STATEMENT to PLANNING INSPECTOR for the Appeal - 14 February 2022

Subject: Planning Inspectorate APP/E0345/W/21/3289748: Vastern Court, RG1 8AL

Subject: Aviva site, Reading Station Park, Vastern Rd, Reading RG1 8AJ - Application 200328

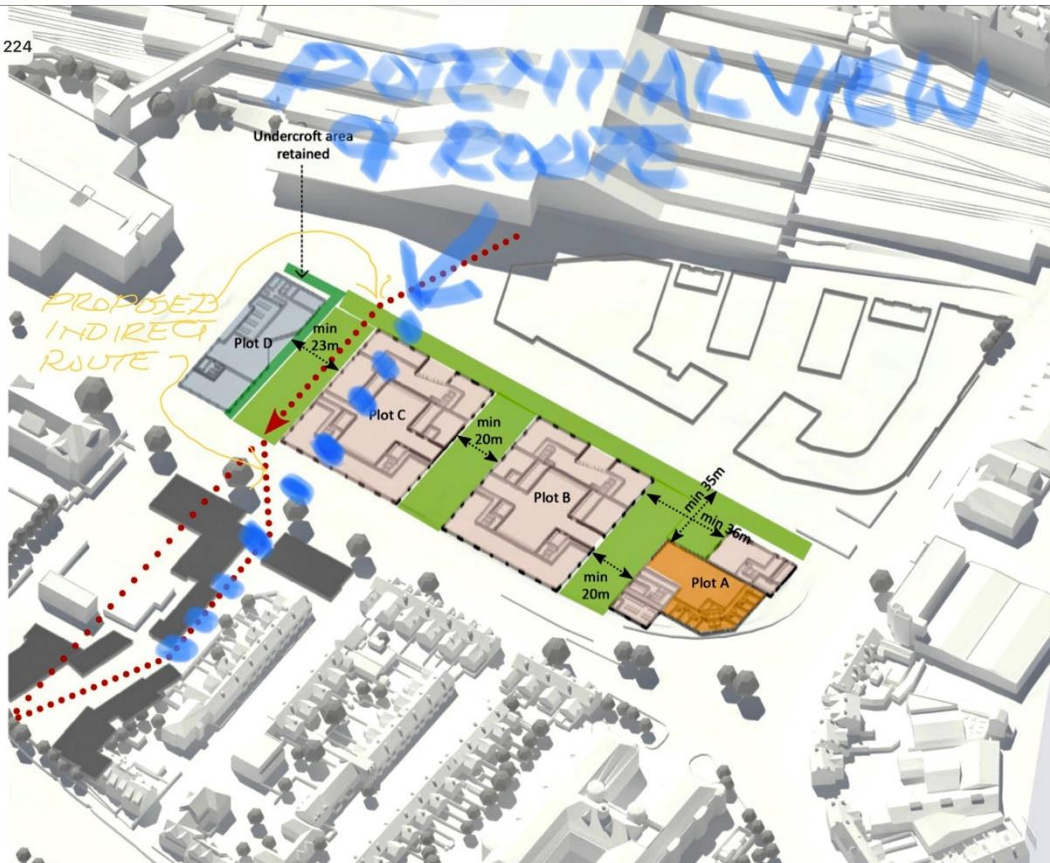
dog leg along the way. In addition the possibility of taking advantage of the View from the new fully glazed first floor station concourse towards the river has been lost. Plot C of the Aviva application now squarely blocks this View. This is a failure of urban design. We attach below a photograph showing the current outlook from the glazed station concourse, which indicates the potential of designing to take advantage of this View. We also enclose a marked up extract from the Applicants Design and Access statement illustrating the indirectness of the route proposed. There has not been liaison between developers on the alignment of the route. Plots D and C should be re-configured to investigate providing a direct route. The future View from the glazed Station Concourse (requested from the Applicant but not forthcoming) should be a fundamental part of the design of both the Aviva and Berkeley sites. Co-ordination of detailed design between developers along the route such as tree species, hard surfacing, street furniture etc would also be beneficial.
